**ADDENDUM NO. 1**

**Chairlift Modernization:**

**Damascus Elementary School**

February 19, 2021

**A1.1**

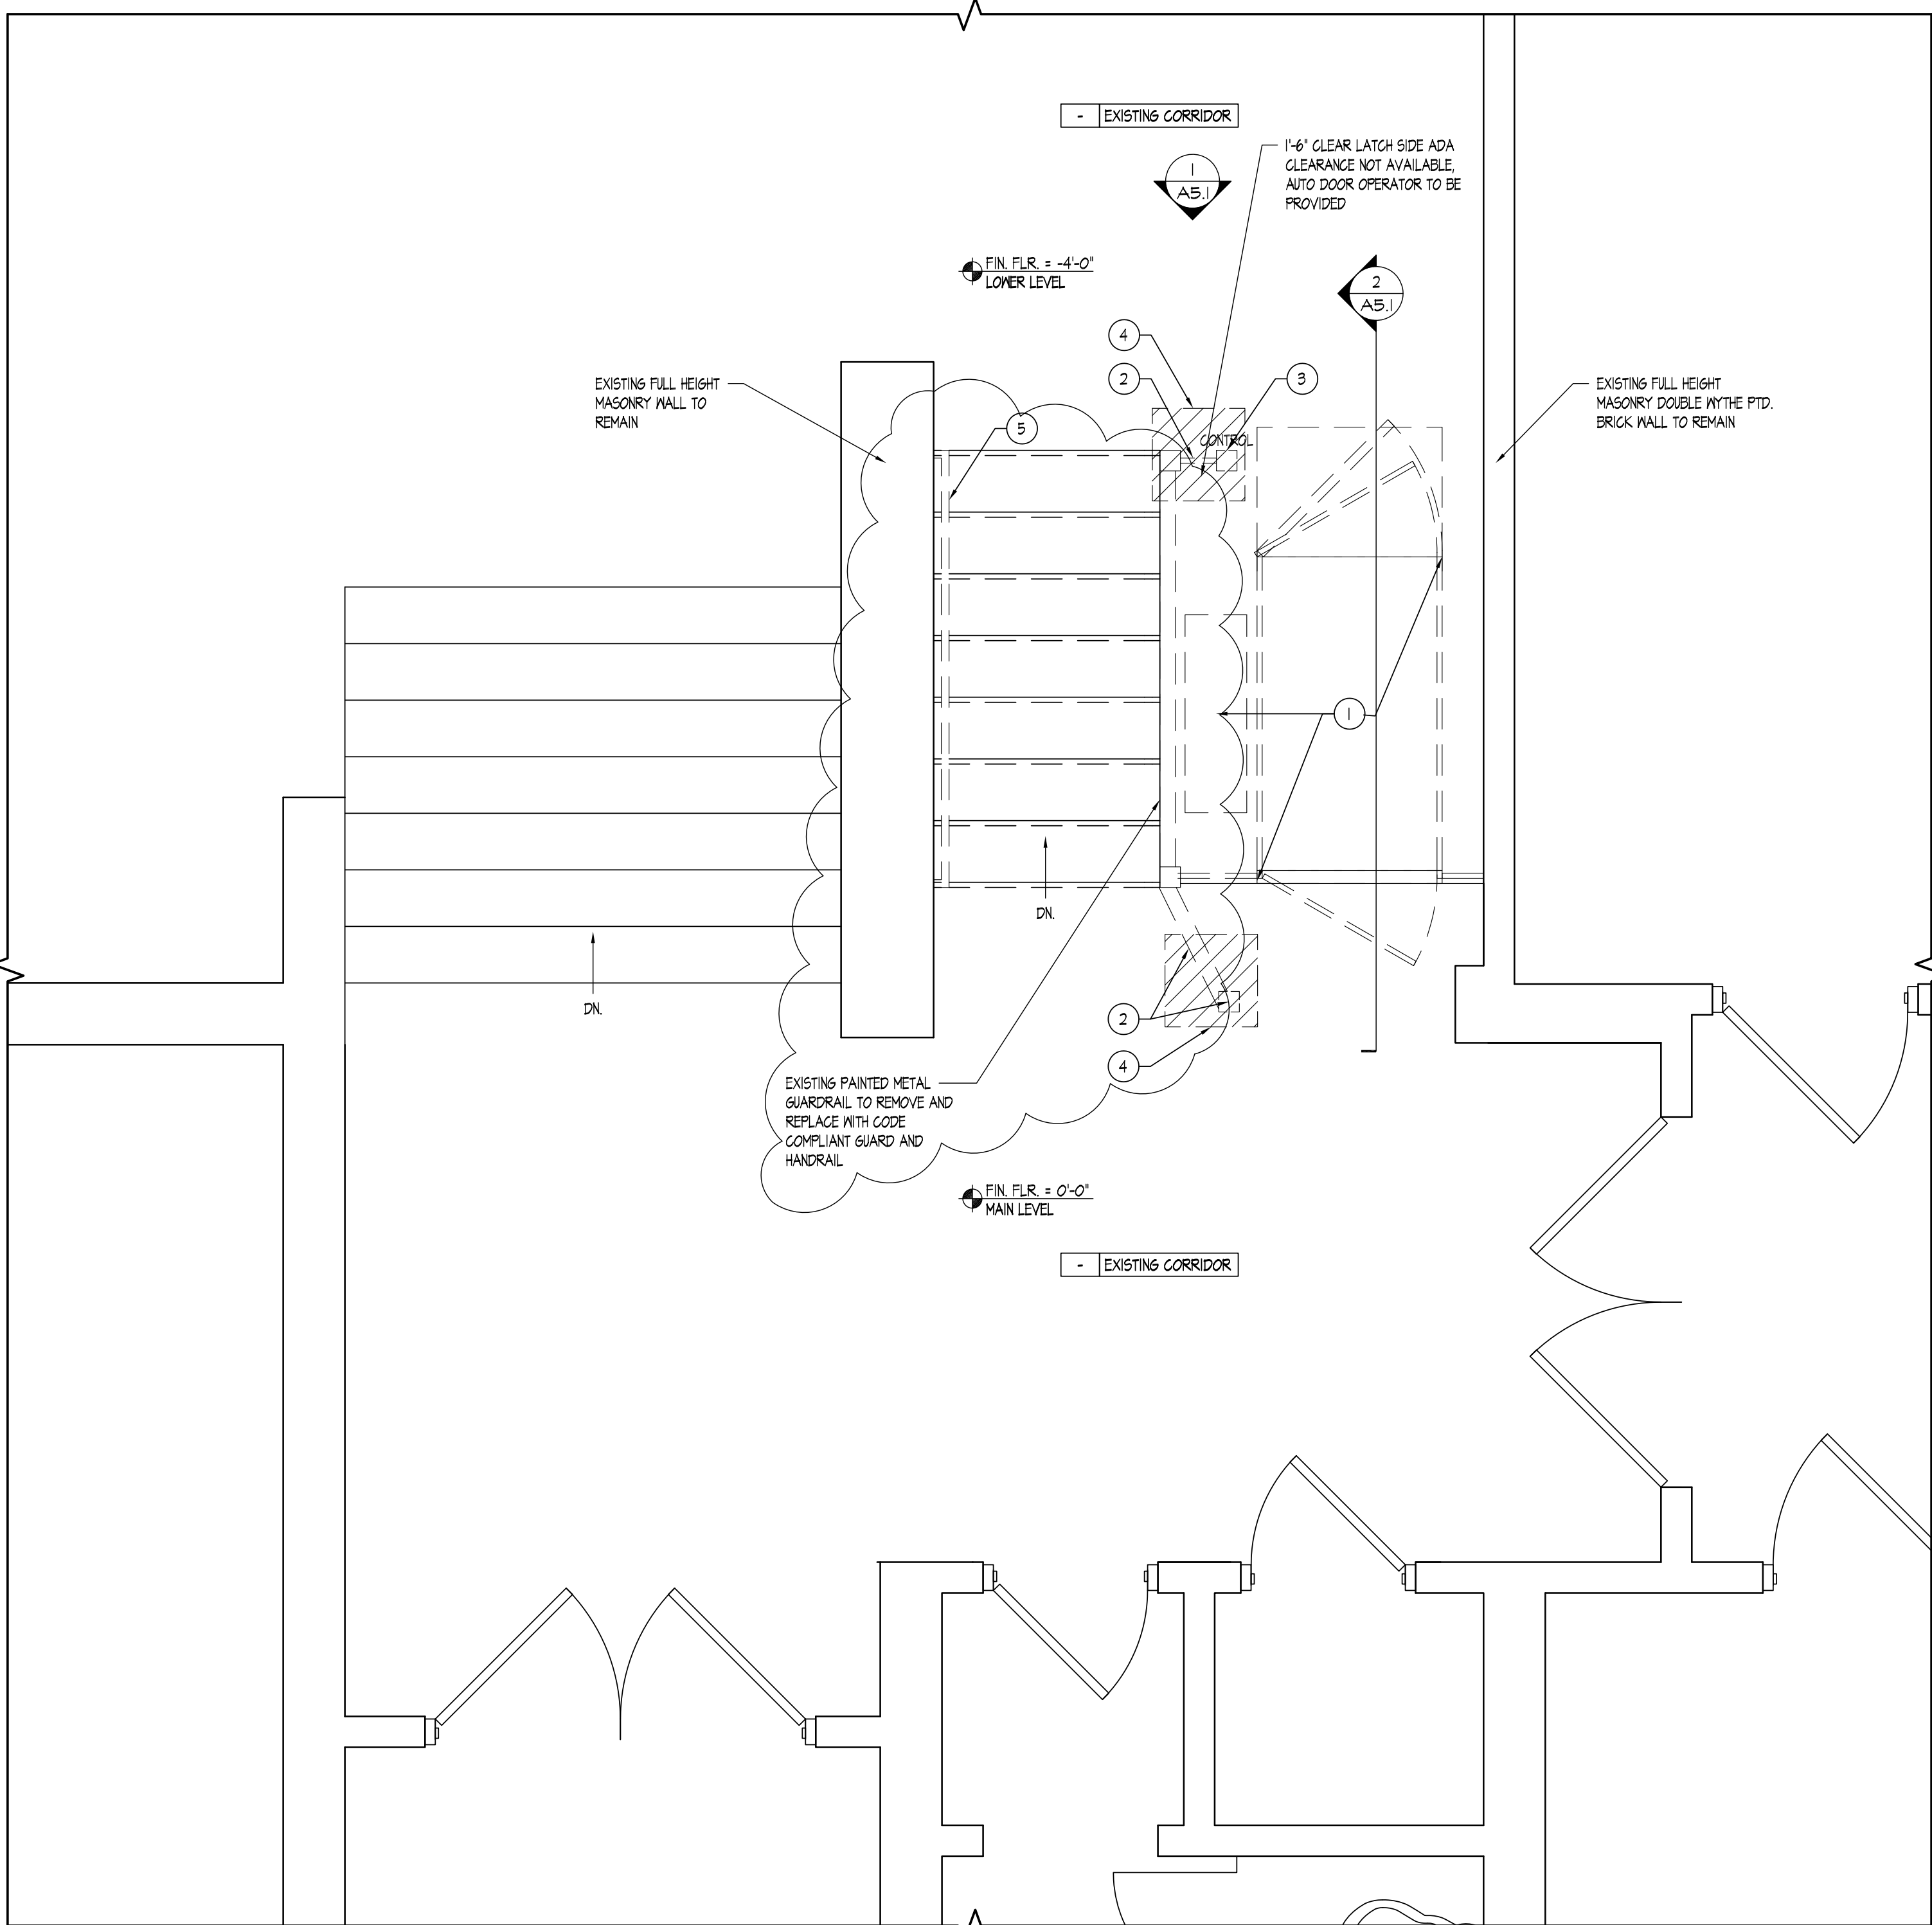
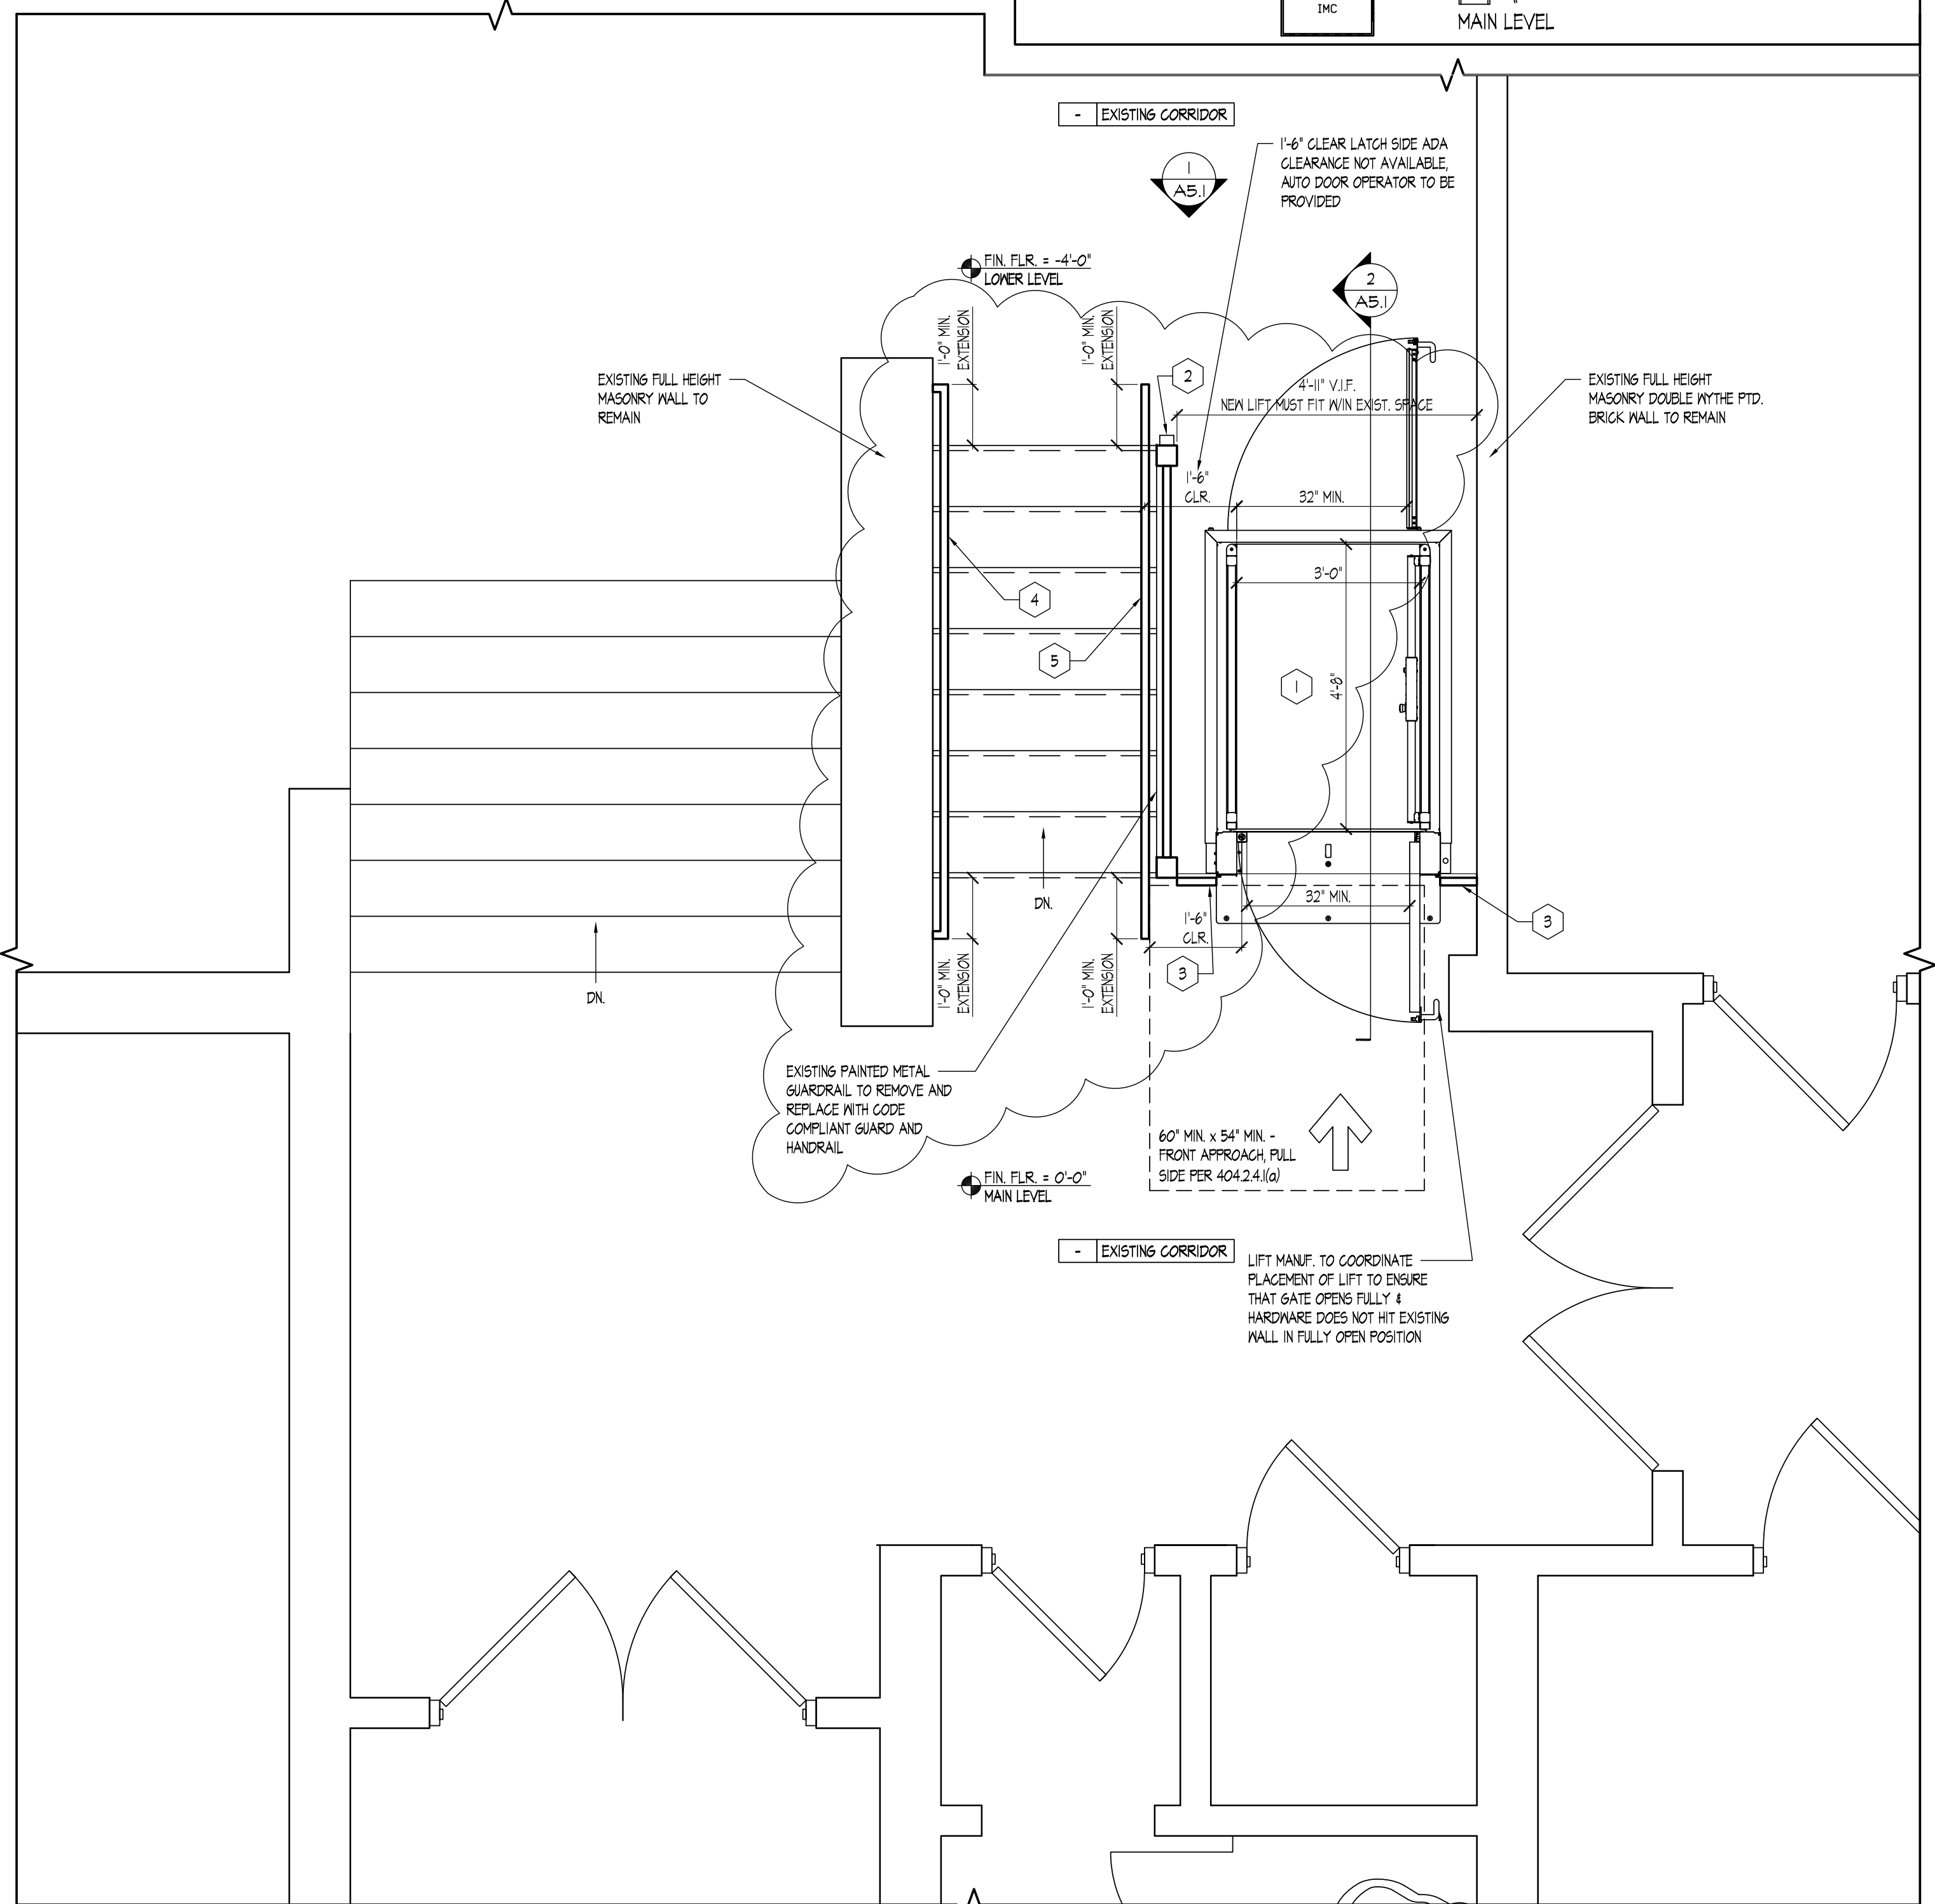
- A1.1 – Handrails on both sides of existing stairs are non-compliant with current codes for height, grip, and location. Drawing A1.1 is revised to demolish the handrail and guardrail on both sides of the existing stair in its entirety and replace with a new code compliant handrail/guardrail.
- A5.1 – Notes pertaining to the above mentioned handrail/guardrail replacement. Existing ceiling slope does not meet required ceiling clearance heights over full extent of new chairlift. Reframe ceiling to meet the 80” required clearance.
- E1.1 – Add “Call Attendant” buttons to connect back to main office.
